**Re: A/YL-KTN/960 DD 107 Sha Po, Kam Tin CDA**  
01/11/2023 02:49

Lots 1866 S.A RP (Part), 1866 S.B RP, 1876 S.B (Part) and 1905 RP (Part) in D.D. 107, and Adjoining Government Land, Sha Po, Kam Tin

Applied Use : 132 Vehicle Parking / 5 Years

Temporary Public Vehicle Park (Excluding Container Vehicle) for a Period of 5 Years

Connection Detail

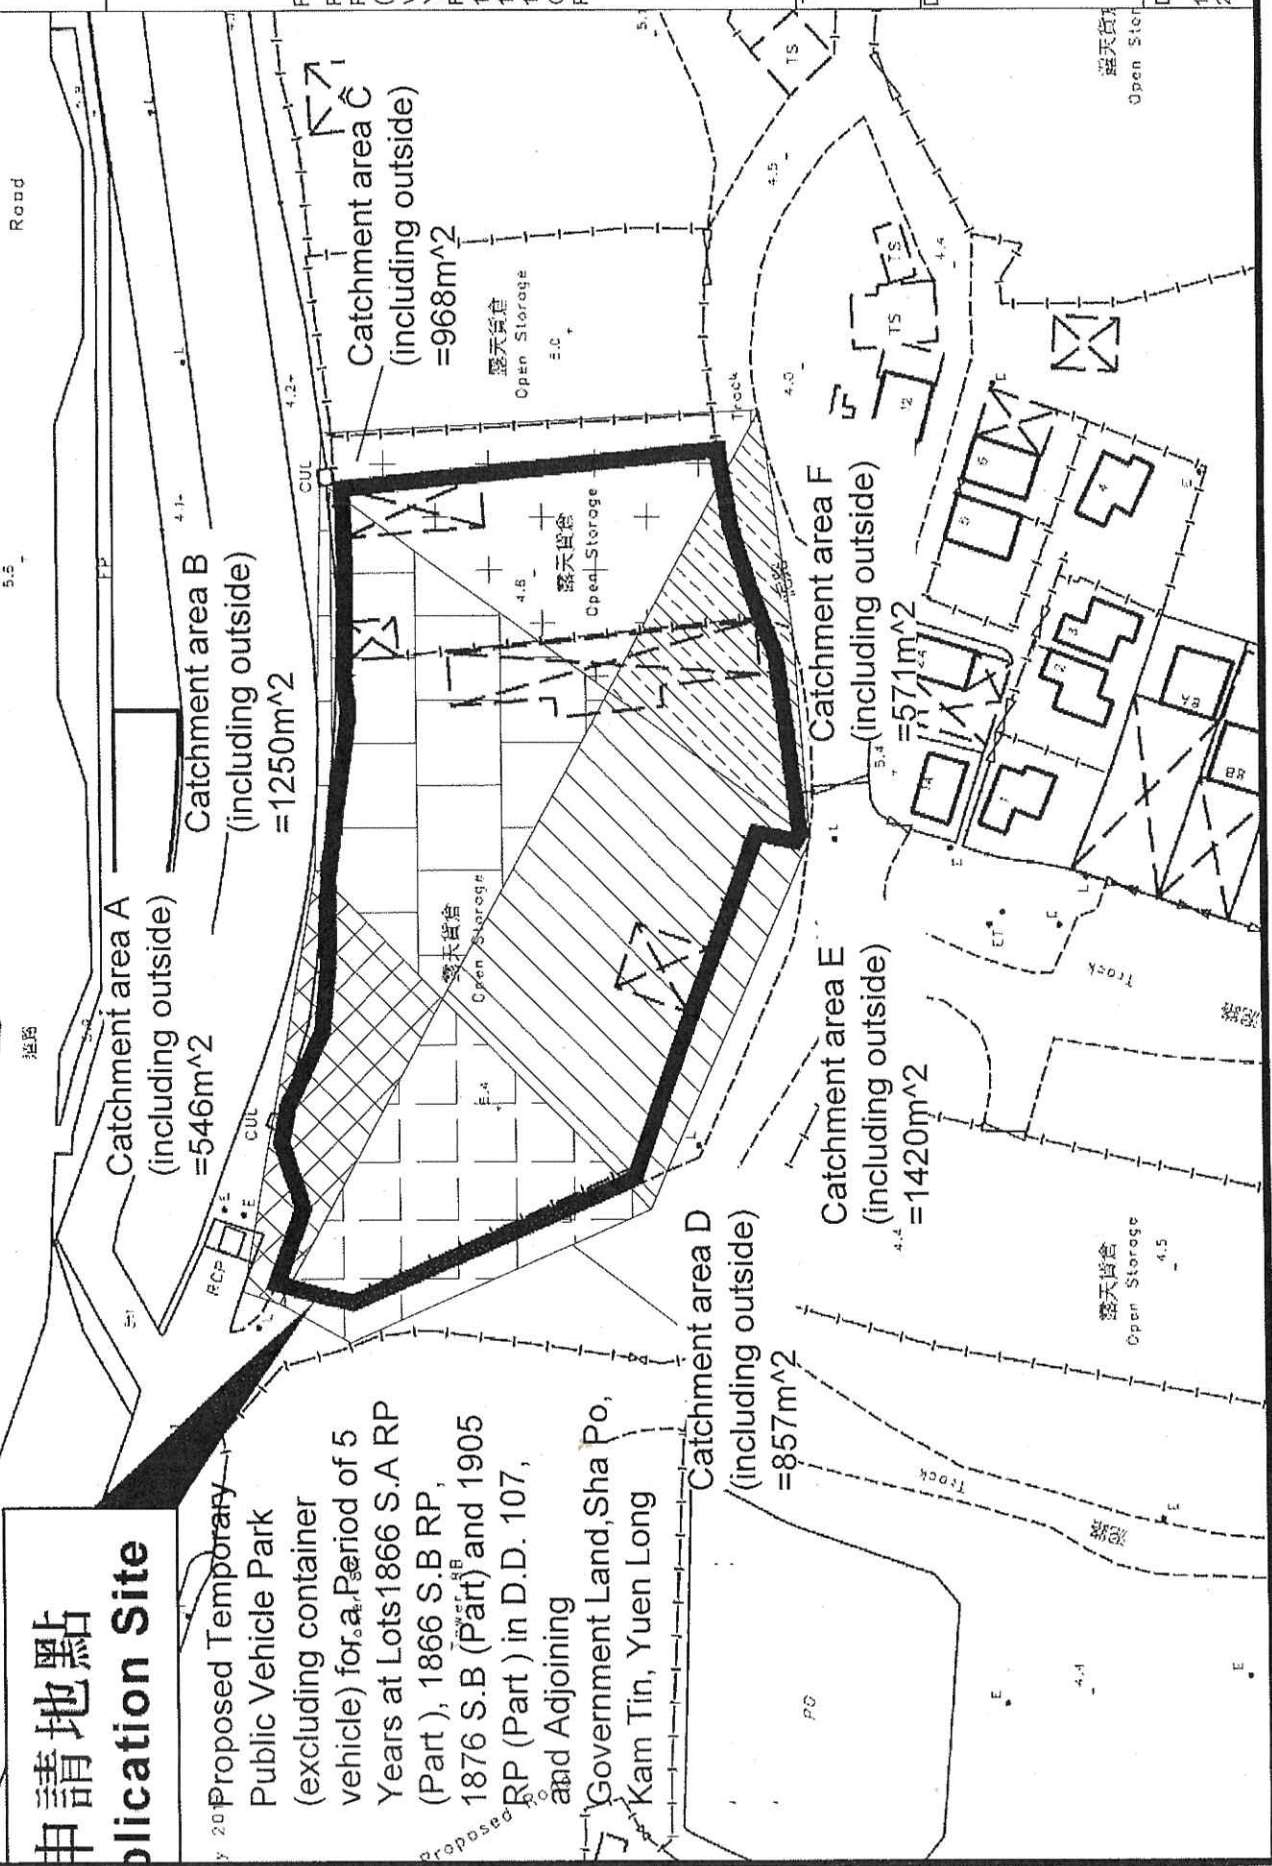
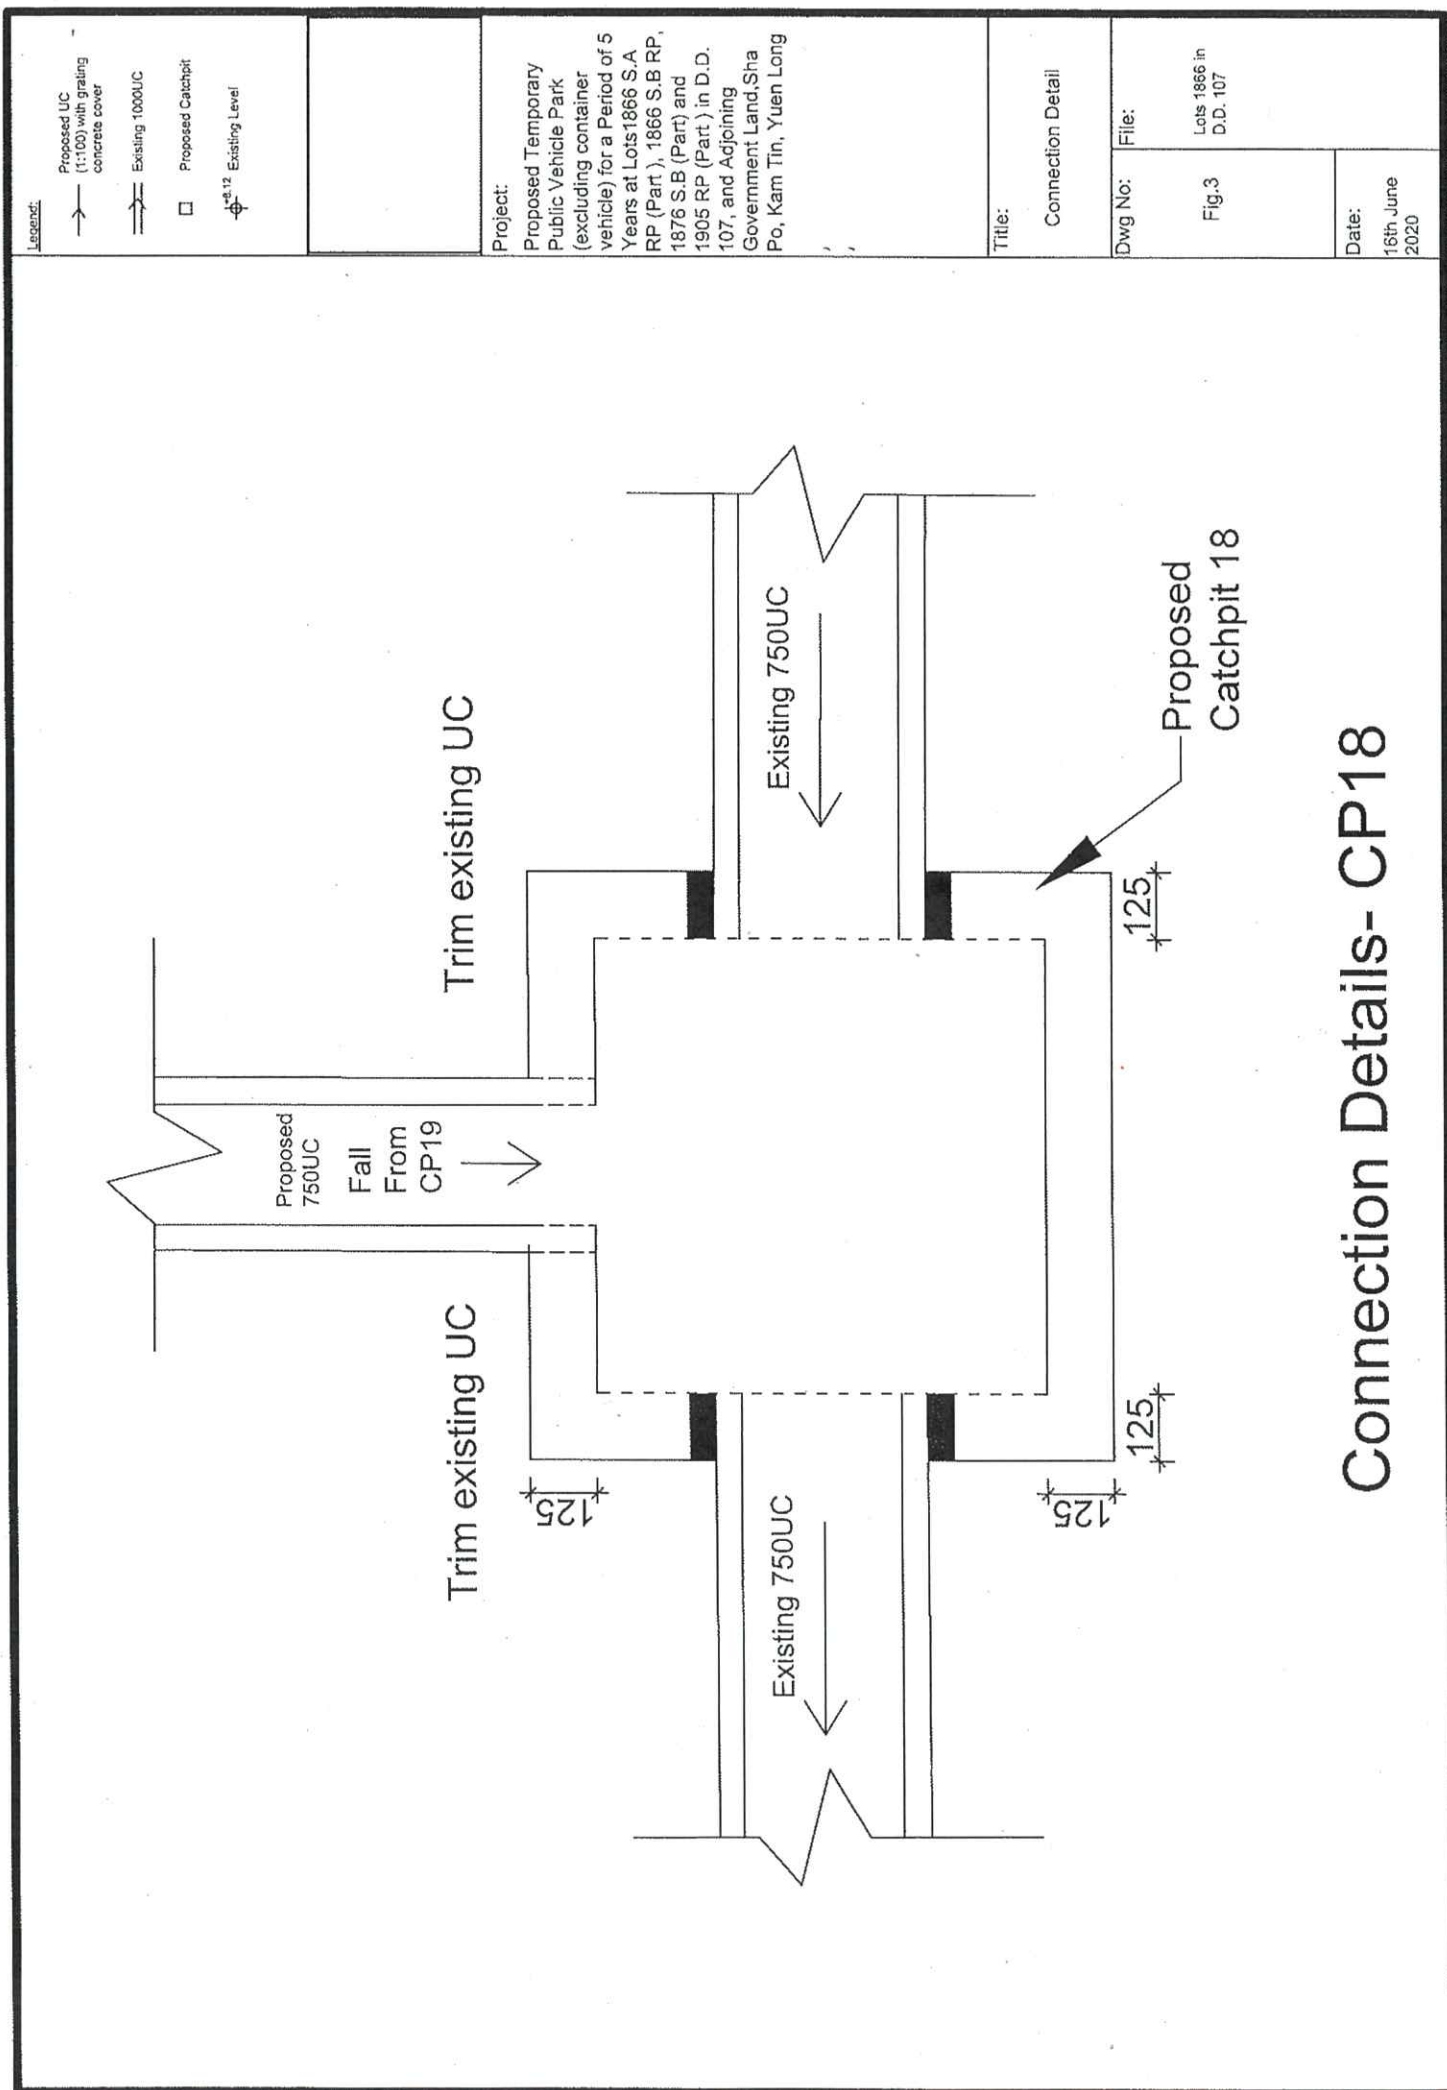
- (ii) there are two CP3, please revise. Please advise the UC sizes from start point to both CP3;
    - (iii) the proposal should indicate how the runoff (the flow direction) within the site would be discharged to the proposed u-channel;

- (iv) cast iron grating is more desirable than the concrete cover because the former has more plan area for runoff collection;
    - (v) it appears that the discharge point is at a DSD's existing u-channel. If the applicant wishes to make any other connection to the public drainage system in the area, please clarify whether the applicant agrees to abide the following:

- (vi) Fig.3 Connection Details - CP18, there is no CP18 so please review this drawing;
  - (vii) the existing drainage facilities, to which the stormwater of the development from the Site would discharge, should be indicated on plan. The relevant connection details such as cross section with levels should be provided for comment;
